Re: Florida Power & Light Company
Proposed Turkey Point Units 6 and 7
Docket Nos. 52-040 and 52-041
Response to NRC Request for Additional Information Letter No. 040 (eRAI 6006)
SRP Section - 02.05.04 Stability of Subsurface Materials and Foundations

NRC RAI Letter No. PTN-RAI-LTR-040

SRP Section: 02.05.04 - Stability of Subsurface Materials and Foundations

Figure 2.5.4-203 Geotechnical Cross Section D-D' Through Unit 6 Power Block

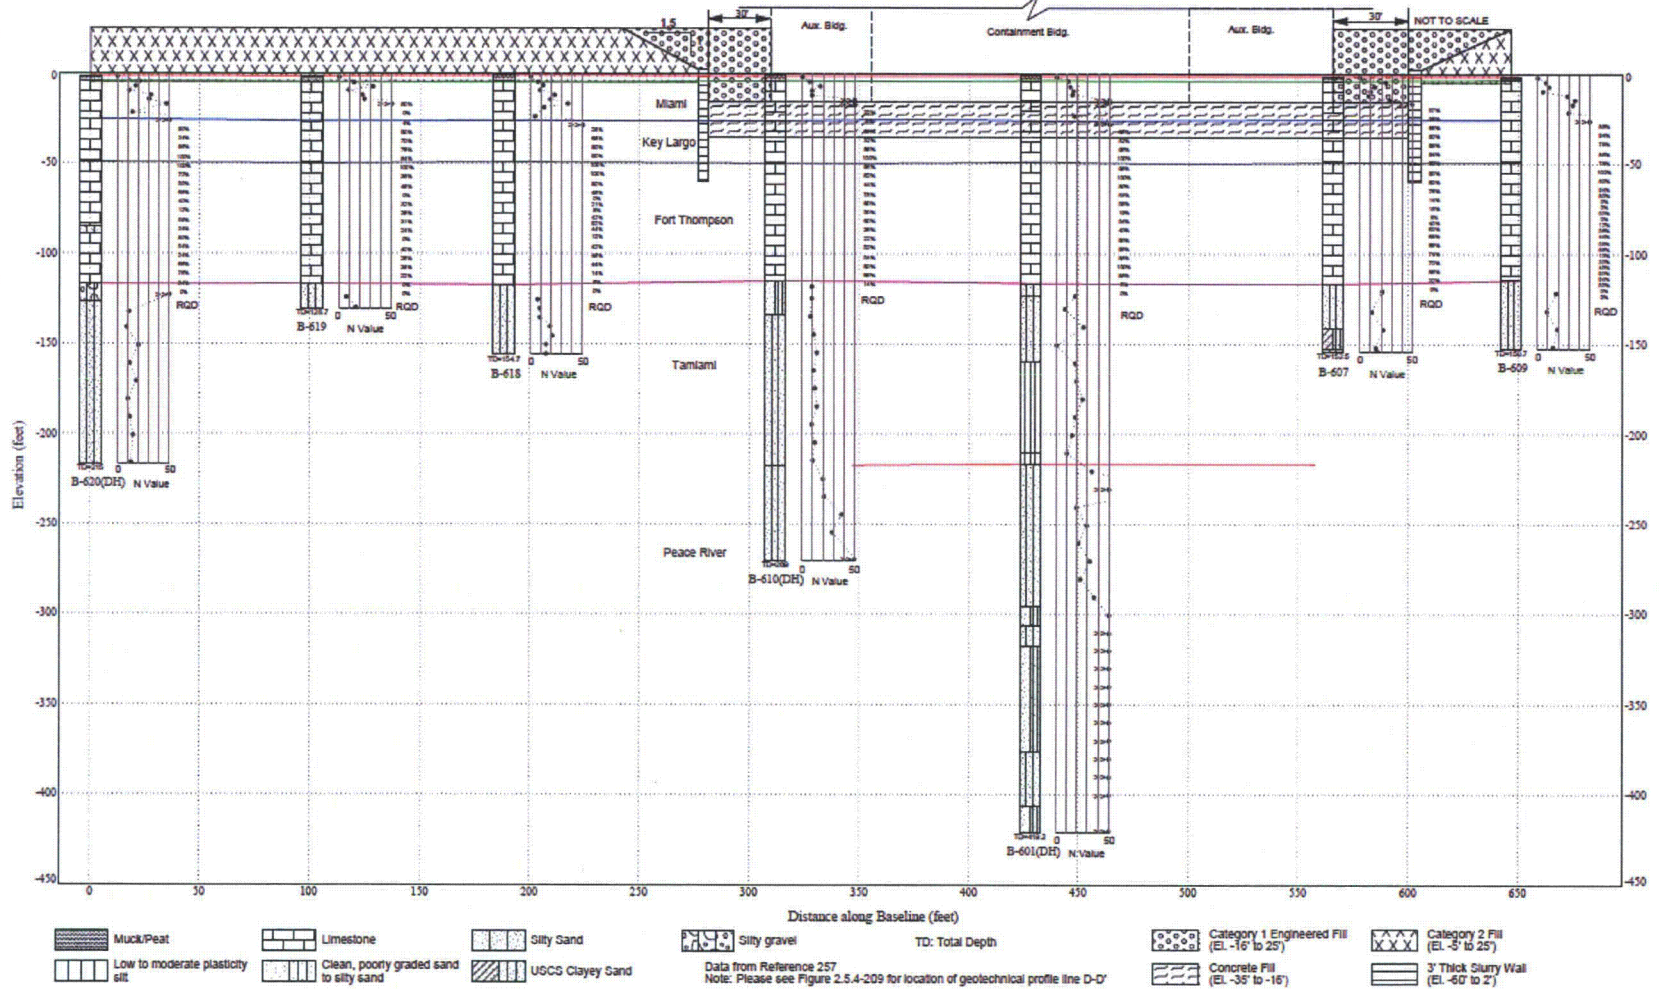
FSAR Figure 2.5.4-222 shows a general conceptual excavation cross-section. In accordance with NUREG-0800, Standard Review Plan, Chapter 2.5.4, "Stability of Subsurface Materials and Foundations," please describe the procedures that will be followed during site excavation and construction activity to ensure that the appropriate strata for the proposed foundation locations are confirmed through objective measures and the exposed foundation laying surface is uniform. Also, please provide the vertical and horizontal extent of all seismic categories I excavations, fills, and slopes, including the locations and limits of excavations, fills, and backfills on plot plans and geologic sections and profiles.

The profiles from the power block subsurface investigation (refer to FSAR Figures 2.5.4-203 through 2.5.4-208) show that the subsurface strata to support foundations are relatively horizontal. However, it should be noted that the extent of excavation to final subgrade and/or to final over-excavation level is determined during construction. This determination is based on observation of actual subsurface conditions encountered, and their suitability for foundation support.

Revised FSAR Figures 2.5.4-203 through 2.5.4-209 will be included in a future FSAR revision to show vertical and horizontal extent of excavations, fill locations and slopes. Note that dimensions and slopes on figures as shown are preliminary pending final design

Figure 2.5.2-249 Median Profiles of Strain-Compatible Soil Damping
(Upper 800 feet) (Sheet 2 of 2)

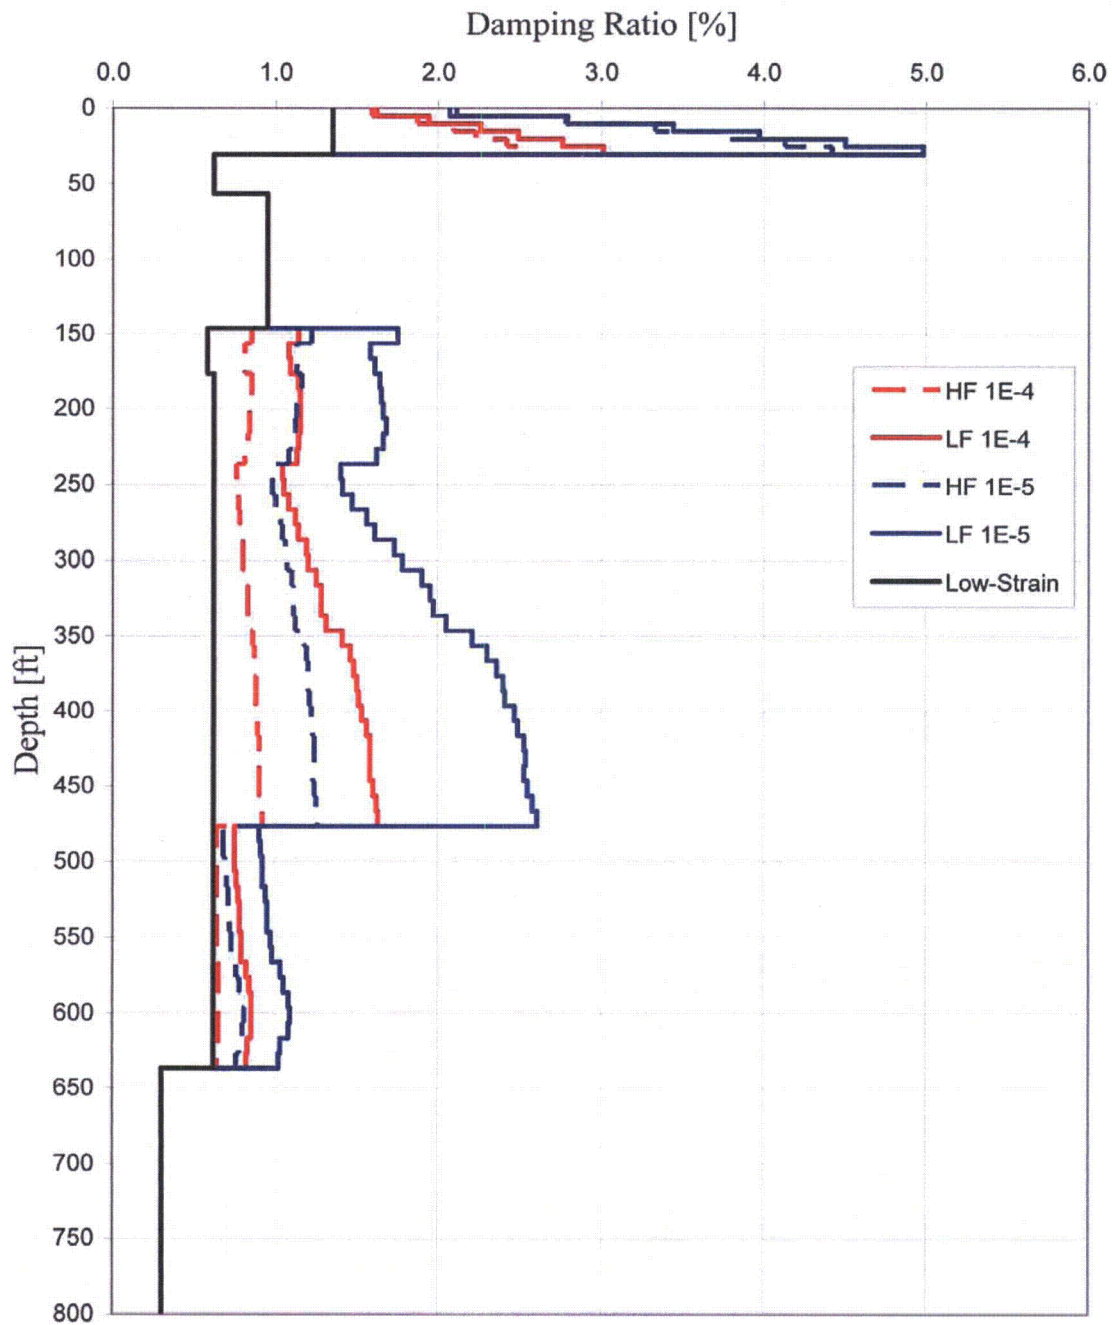
Section 2.5.4.7.3.3 "Shear modulus and Damping for Rock", indicates that the damping for rock is taken as 1%. The damping shown in Figure 2.5.2-249, which describes the soil properties used to develop the GMRS, indicates that a damping value of 0.5% was used in the analyses. In accordance with NUREG-0800, Standard Review Plan, Chapter 2.5.4, "Stability of Subsurface Materials and Foundations," please provide clarification as to the actual level of damping used in the analyses and provide a basis for its selection considering the large variability in RQD shown in Figure 2.5.4-215.

FSAR Figure 2.5.2-249 (Sheet 2 of 2) is reproduced in this response for illustrative purposes. This figure represents the full soil and rock column that includes approximately 30 ft of structural fill (with surface at El. +25.5 ft) above approximately 25 ft of Miami Limestone, overlying about 90 ft of rock consisting of the Key Largo and Fort Thompson Formations. The rock is underlain by soil of the Tamiami and Peace River Formations to about 470 ft depth. The Arcadia Formation, consisting of very weak rock mixed with some soil extends to about 640 ft depth, the limiting depth of the site subsurface investigation. The actual levels of damping used in the analyses are the values shown in FSAR Figure 2.5.2-249. The basis for selecting the value for each formation is described in the following paragraphs.

FSAR Subsection 2.5.4.7.3.3 indicates that the Miami Limestone is considered sufficiently weak to have a strain-dependent modulus and damping values. FSAR Table 2.5.4-216 shows the damping ratio (D%) versus shear strain values. D remains constant at 0.6% from 0.0001% to 0.03% strain. In the SHAKE analysis, shear strain did not exceed 0.03%, and so D is constant at 0.6% in FSAR Figure 2.5.2-249. D = 1% at all strain levels for the Key Largo and Fort Thompson Formations (Strata 3 and 4) as stated in FSAR Subsection 2.5.4.7.3.3, which notes that damping in these formations is not strain dependent.

The only other rock formation noted in FSAR Subsection 2.5.4.7.3.3 is Stratum 8, the Arcadia Formation. This formation is included with the Key Largo and Fort Thompson Formations in FSAR Subsection 2.5.4.7.3.3 as being non strain-dependent, and having D constant at 1%. The Arcadia formation is much weaker than the Key Largo and Fort Thompson Formations. FSAR Table 2.5.4-209 indicates an unconfined compressive strength of 100 psi compared with 1,500 and 2,000 psi for the Key Largo and Fort Thompson Formations, respectively. Even the strain-dependent Miami Limestone has double the strength of the Arcadia Formation. Thus, for the Arcadia Formation, consideration was given to using the D versus shear strain values of the Miami Limestone

Figure 1. 5% Damping ARS at Ground Surface – Near NI, Envelope of LF and HF

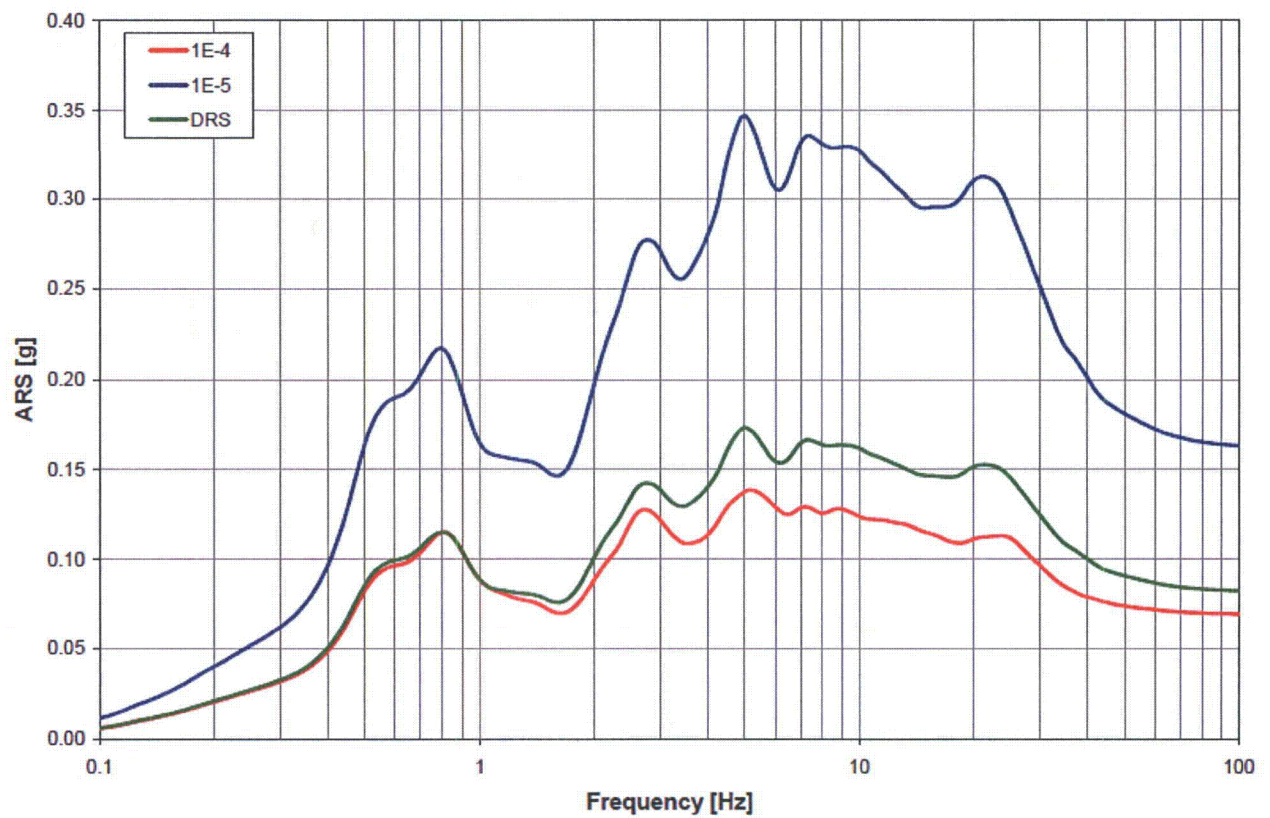
The lateral earth pressure diagram shown in Figure 2.5.4-240 shows a plot corresponding to the dynamic lateral earth pressure. The shape of this plot appears to be consistent with the shape for dynamic pressure considering a rigid structural wall (see ASCE 4). In Section 2.5.4.10.4.2 "Seismic Lateral Earth Pressures", the active seismic pressure was computed using the Mononobe-Okabe equation. The last sentence of the section indicates that at-rest pressure as a function of depth for below-grade walls is developed consistent with Reference 277 (ASCE-4) using the design ground motion. It is noted that the pressure developed using the ASCE-4 methodology uses the z_{pa} value from the input motion.

Figure 2.5.2-252 shows the input motion (GMRS) developed for the site, the GMRS is located at Elevation 35 [sic]. In this Figure the z_{pa} is approximately 0.058g. However, the elevation of the GMRS is considerably lower than the surface of the soils adjacent to the basement walls that are to be evaluated for seismic lateral earth pressure. In accordance with NUREG-0800, Standard Review Plan, Chapter 2.5.4, "Stability of Subsurface Materials and Foundations," please clarify on the definition of the design ground motion, and how that motion is consistent with Appendix S to 10CFR50.

The Design Response Spectra (DRS) at 5% damping are calculated at the ground surface for the near Nuclear Island (NI) and far from NI soil sites using the envelope of low frequency (LF) and high frequency (HF) acceleration response spectra (ARS) at 10^{-4} and 10^{-5} annual probability of exceedance. These ARS envelopes and the DRS are plotted in Figures 1 and 2 for the near NI and far from NI soil sites, respectively. From Figures 1 and 2, the peak ground acceleration at the ground surface is equal to approximately 0.0824g and 0.0806g (DRS at 100 Hz) for the near NI and far from NI soil sites, respectively.

Regarding the computation of active seismic pressure using the Mononobe-Okabe equation, according to Whitman (1991), use of horizontal ground acceleration for design at the base level of the wall may result in underestimating the movements; it seems best to use the acceleration at the surface of the backfill, or an average between the surface and the base of the wall. Thus, an acceleration of 0.1g, rather than the peak ground acceleration of 0.0824g (near NI) or 0.0806g (far from NI), is conservatively used in the Mononobe-Okabe equation.
